# CITY OF ALBUQUERQUE

February 16, 2024

**Re: Markana Flats**  
**7050 Constitution Ave. NE**  
**Traffic Circulation Layout**  
Architect's Stamp 08-16-23 (J19-D047A)

## LOWER LEVEL PLAN

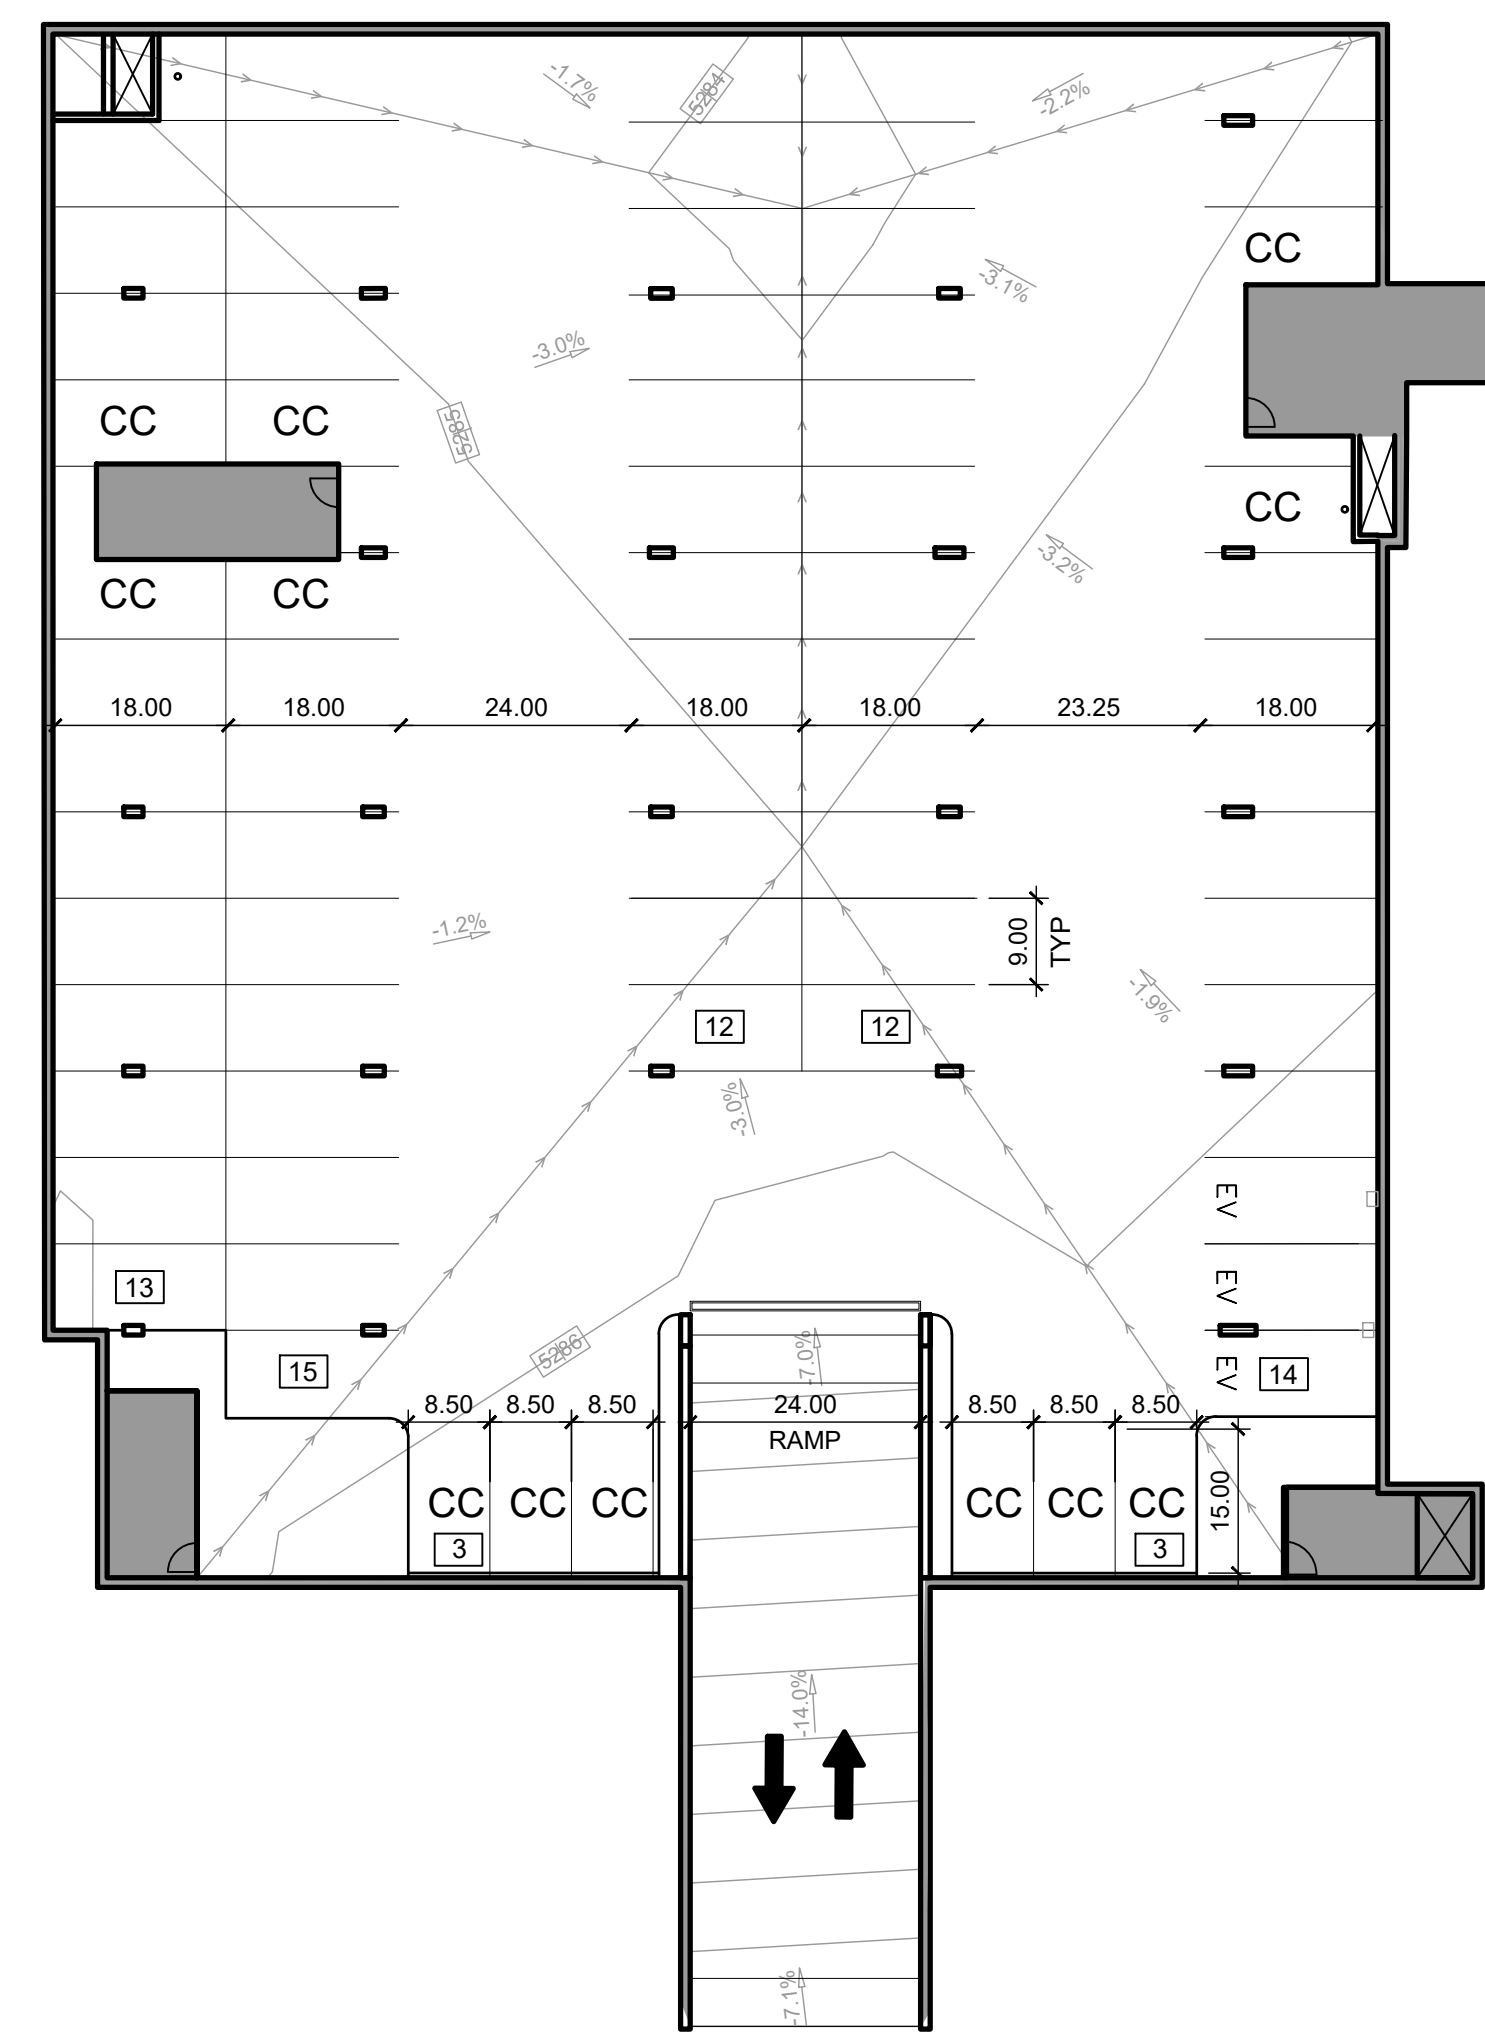
6. Keynote 10: please show on the site plan the dimensions of the clear sight triangle.
7. A 5 ft. keyway is required for dead-end parking aisles for the lower level plan.

## ARCHITECTURAL SITE PLAN

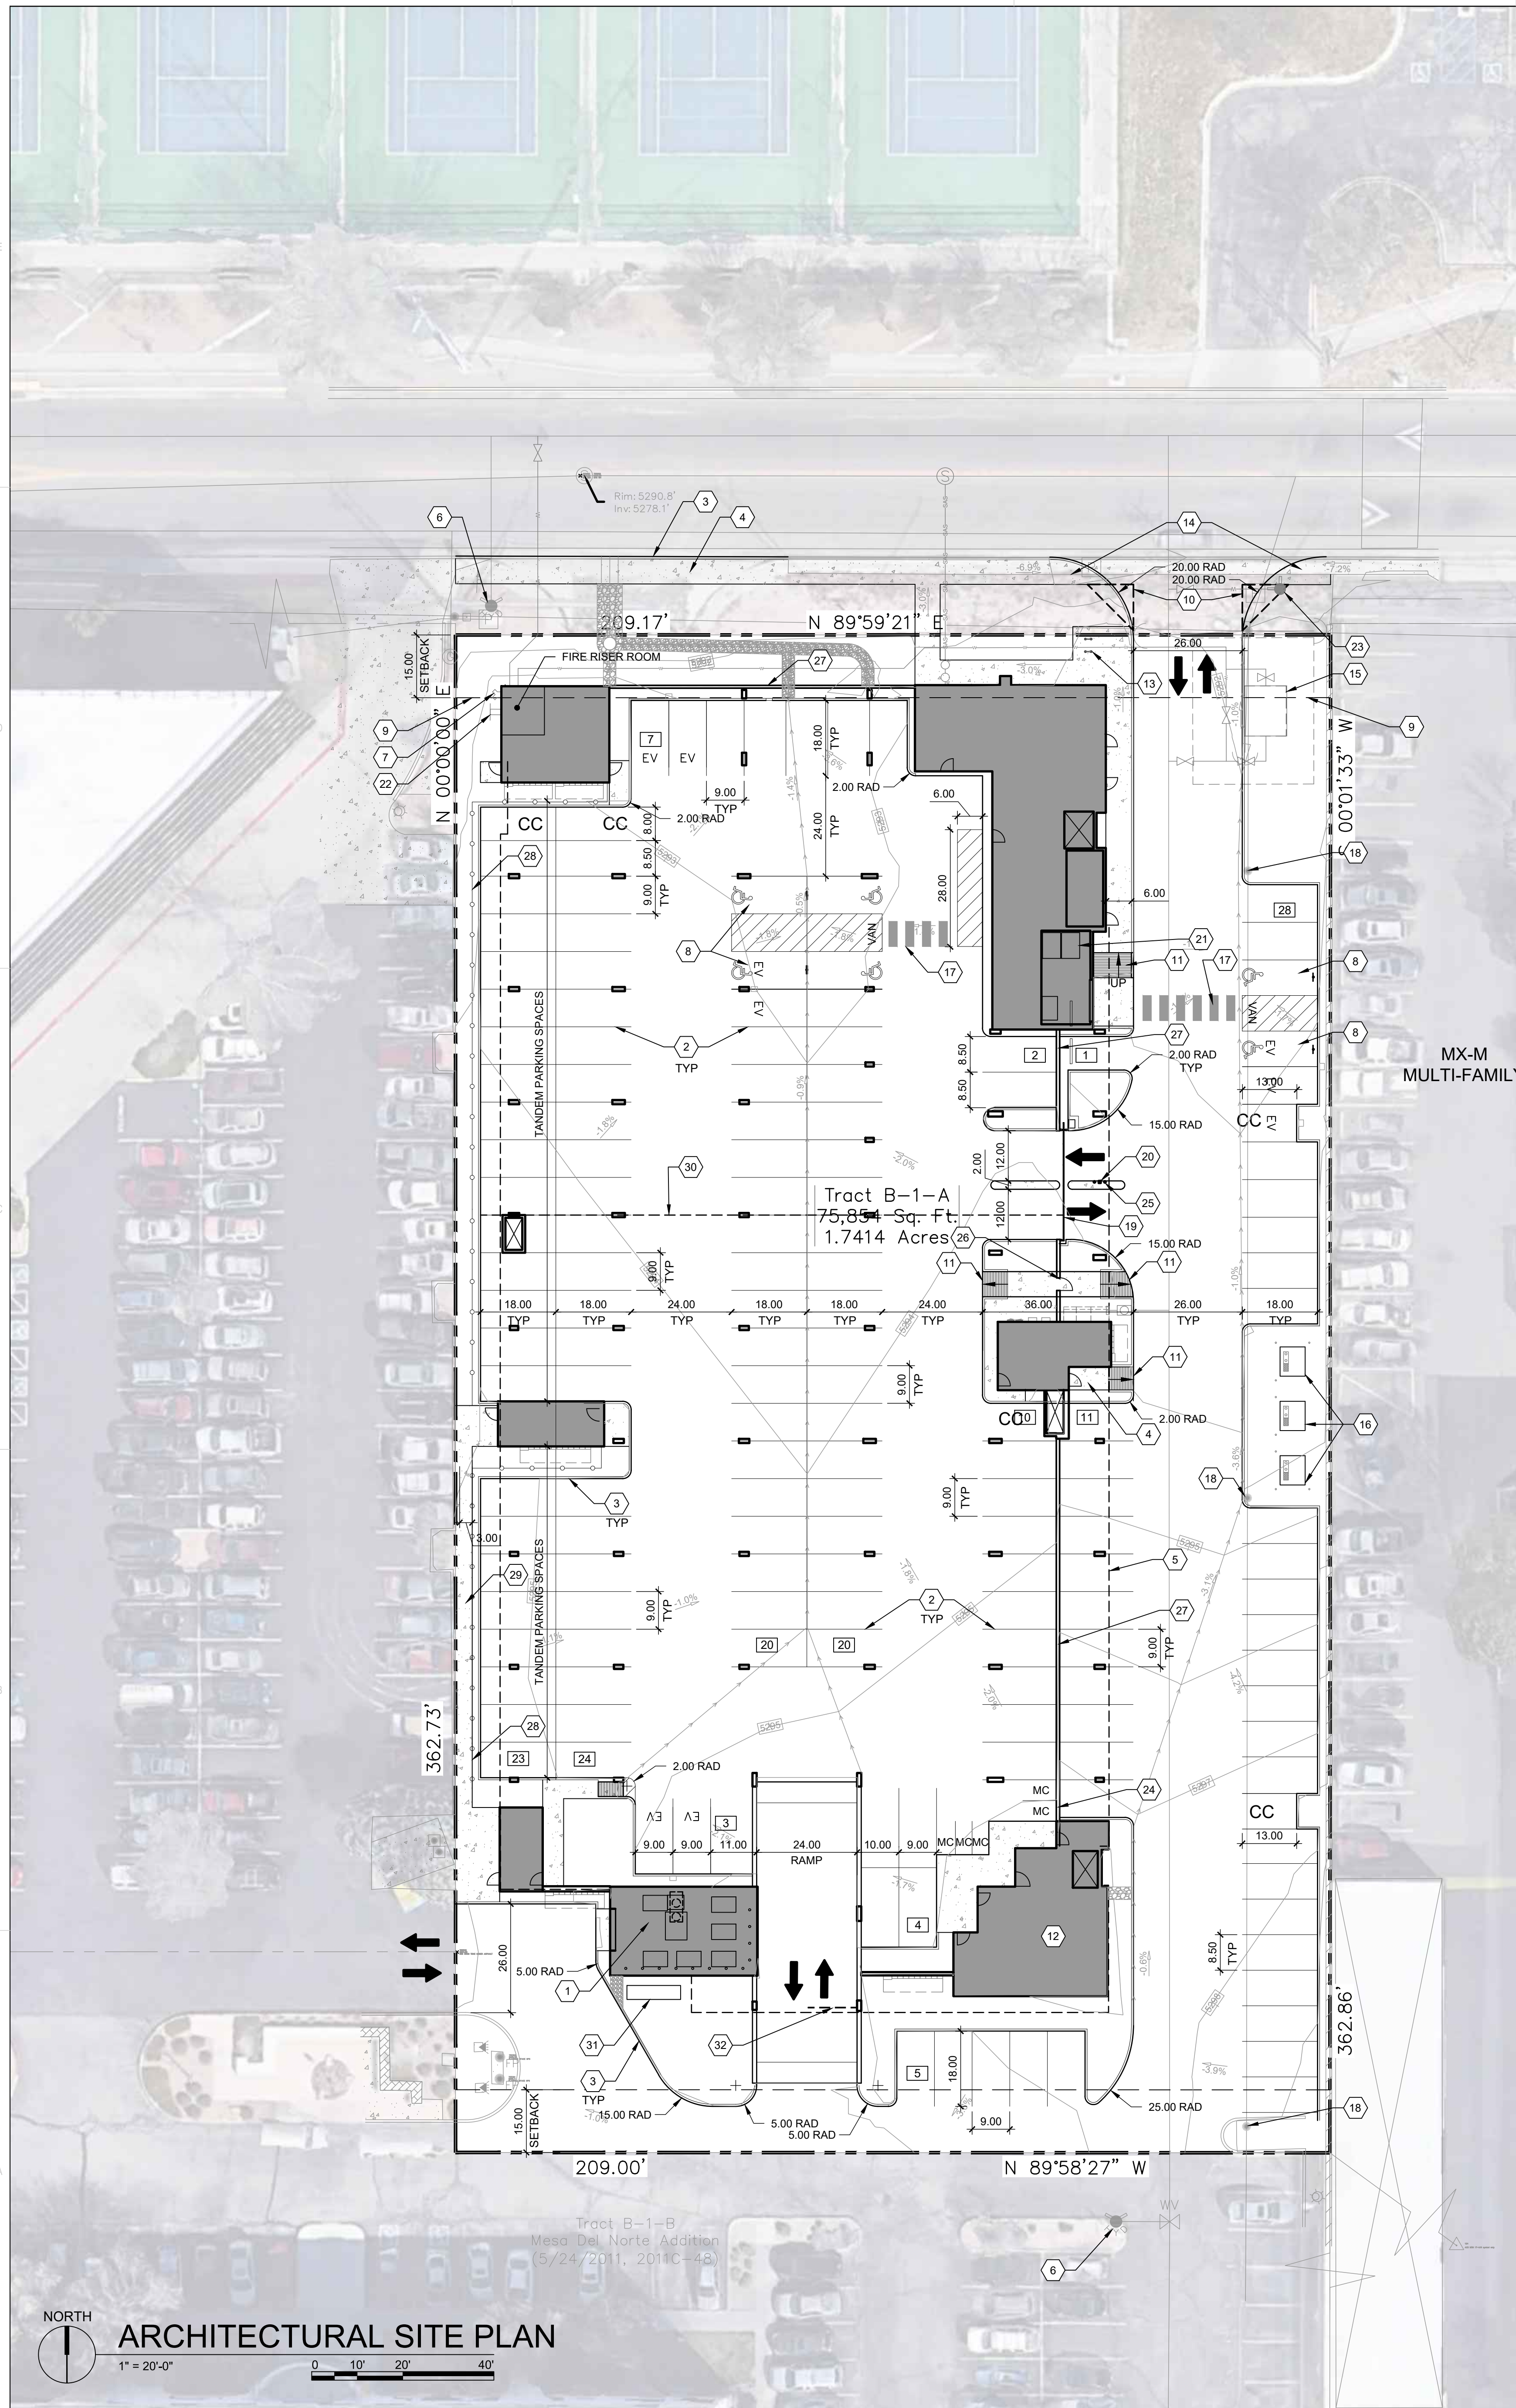
1. Please provide a clear copy of the approved recorded easement, as the one you provided is blurry and unreadable.
2. Per Google aerial view, there are power poles on the east side of the site. Please show those poles on the site plan and provide an easement.

3. Please explain how the Tandem Parking spaces will be managed?
4. Show on the parking table requirement, how many Motorcycle and EV parking space are required.

8. Please show on the site plan how wide is the concrete columns to ensure that they do not impact the width of the proposed parking spaces.
9. Please clarify whether the ADA pathways from the ADA aisles to the building entrance are flush all the way long.

10. Label the compact parking spaces by placing the words "**COMPACT**" on the pavement of each space.
11. Keynote 27: Parking areas shall have barriers to prevent vehicles from colliding with the wall/ fence.

12. Refuse vehicle maneuvering shall be contained on-site. The refuse vehicle shall not back into the public right of way.; provide a copy of refuse approval.

13. Provide a copy of Fire Marshal approval.
14. It is not apparent what type of pavement surface is being proposed. A hard driving surface will be required as part of this proposed project for parking area and drive aisles.

B5  
POLE MOUNTED SIGN

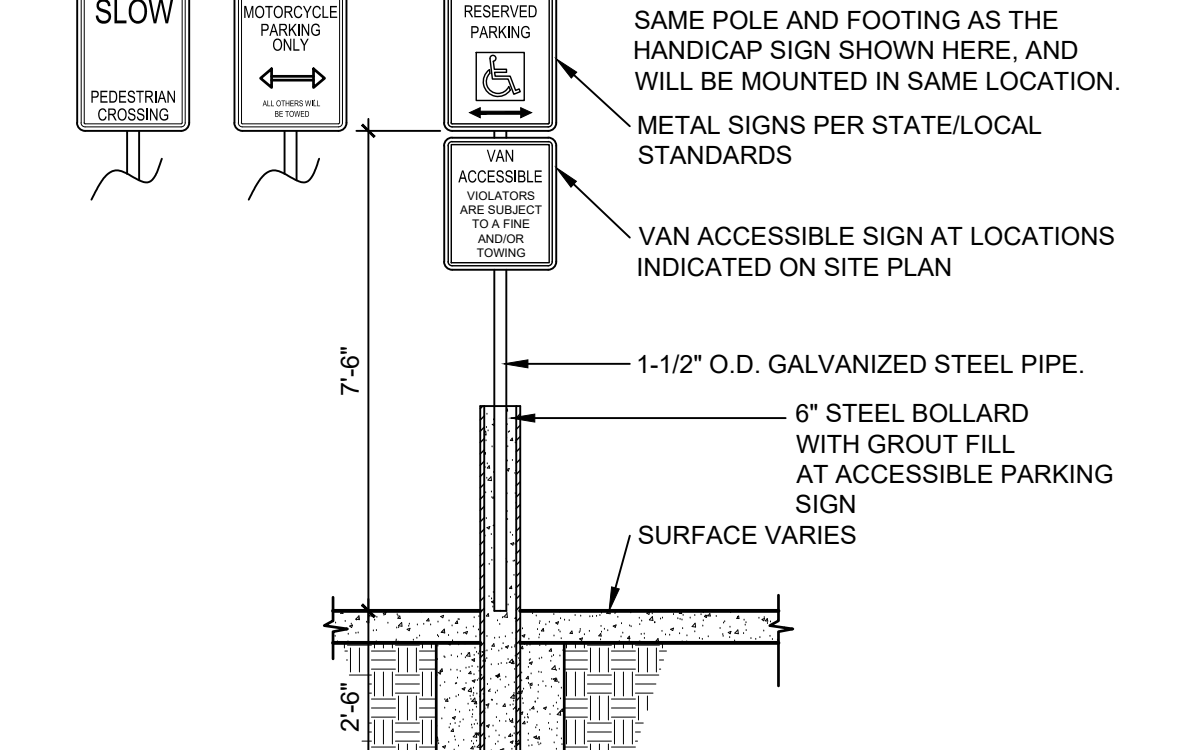
5. The ADA accessible parking sign must have the required language per 66-7-352.4C NMSA 1978 **"Violators Are Subject to a Fine and/or Towing."** Please call out detail and location of signs.
